# Transient section 145.3.8.6 v103

### 145.3.8.6 PD behavior during transients at the PSE PI

**Figure 145-31—Transient test conditions operating bounds**

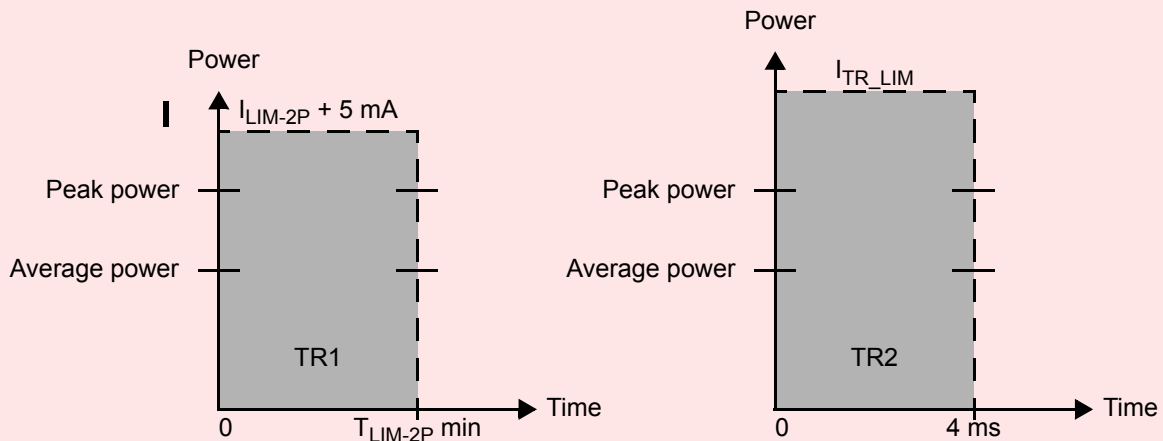
- Figure 145–31 tries to show an overview of the PD requirements when exposed to transients TR1 and TR2. Issues:
- The Figure and description of parameters used is a complete duplicate of normative information in the same subclause
  - It doesn't add any new information or insight
  - The Figure y axis is labeled “power” but at the top of the box a current level is denoted
  - $T_{LIM-2P}$  (PSE parameter) is tied to PSE Type. It is 10 ms for Type 3 and 6 ms for Type 4. The PD does not see the difference between a Type 3 and a Type 4 PSE, hence the reference to  $T_{LIM-2P}$  needs to be replaced by “6 ms”.

The proposed resolution is to remove the Figure and description and correct the text accordingly.

Table 145–29 defines two PSE transient conditions and PD Types to which these apply. ~~Figure 145–31 shows operating bounds for the transients in Table 145–29. The shaded regions begin with the application of the transient and end at the times indicated in the Figure. These shaded regions can exceed normal operating limits and are not included in the average and peak operating power requirements set forth in Table 145–28. During a transient the input power of the PD may exceed  $P_{Peak\_PD}$ .~~

Having a dependence to  $T_{LIM-2P}$  in the PD section per D2.4 is an issue, since the value of  $T_{LIM-2P}$  depends on Type. The PD can't see the difference between Type 3 and Type 4.

When ~~the PD is operating under its worst-case current draw for its assigned Class and~~ transient TR1 is applied, the PD shall meet the operating power limits after  $T_{LIM-2P\ min}$  as defined in ~~Figure 145-31~~ Table 145-28.

When transient TR2 is applied, the peak current shall not exceed  $I_{TR\_LIM}$ , as defined in Table 145-30, and the PD shall meet the operating power limits after 4 ms ~~as defined in Figure 145-31~~.
